APPLICATION NO.	FILING DATE	FIRST NAMED INVENTOR	ATTORNEY DOCKET NO.	CONFIRMATION NO.
10/588,536	08/07/2006	Fernando Garofoli	06170-PCT-PA (0030.0567)	9569
7590 09/02/2008 Armstrong Westerman and Hattori 502 Washington Avenue		EXAMINER		
			FULTON, KRISTINA ROSE	
Suite 220 Towson, MD 21	1204 ART UNIT PAPER		PAPER NUMBER	
,			3673	
			MAIL DATE	DELIVERY MODE
			09/02/2008	PAPER

Application No.	Applicant(s)				
	10/588,536	GAROFOLI, FERNANDO				
Office Action Summary	Examiner	Art Unit				
•	KRISTINA FULTON	3673				
- The MAILING DATE of this communication appears on the cover sheet with the correspondence address - Period for Reply						
A SHORTENED STATUTORY PERIOD FOR REPLY IS SET TO EXPIRE 3 MONTH(S) OR THIRTY (30) DAYS, WHICHEVER IS LONGER, FROM THE MAILING DATE OF THIS COMMUNICATION. - Extensions of time may be available under the provisions of 37 CFR 1.136(a). In no event, however, may a reply be timely filed after SIX (6) MONTHS from the mailing date of this communication. - If NO period for reply is specified above, the maximum statutory period will apply and will expire SIX (6) MONTHS from the mailing date of this communication. - Failure to reply within the set or extended

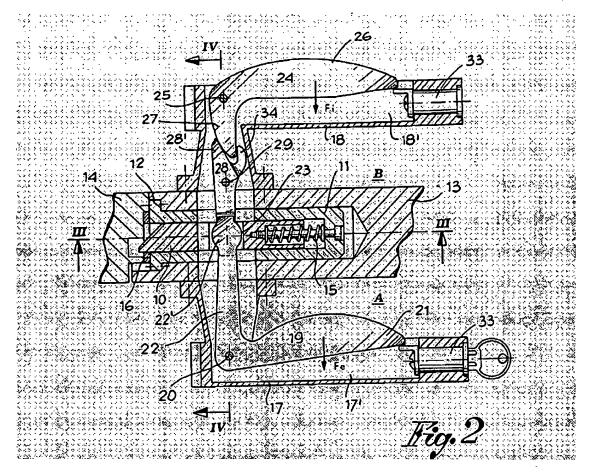
Claims 1-15 are rejected under 35 U.S.C. 102(b) as being anticipated by Pedersoli (DE4009764). "As best understood" Pedersoli shows internal and external handles (17 and 18) having an opening lever (22 or 27) and an opening button (26 or 21). The handle further include a vertical lever (28) having a fork (29). The device includes a spring (15) within a housing (11) and a latch mechanism (10). The door handle further shows a cylindrical chamber (at each end of handle for cylinder 33). The handle includes a cylinder (33) for locking the handle with a key (see illustration below). The handle is an L shape. See the Pedersoli device below.
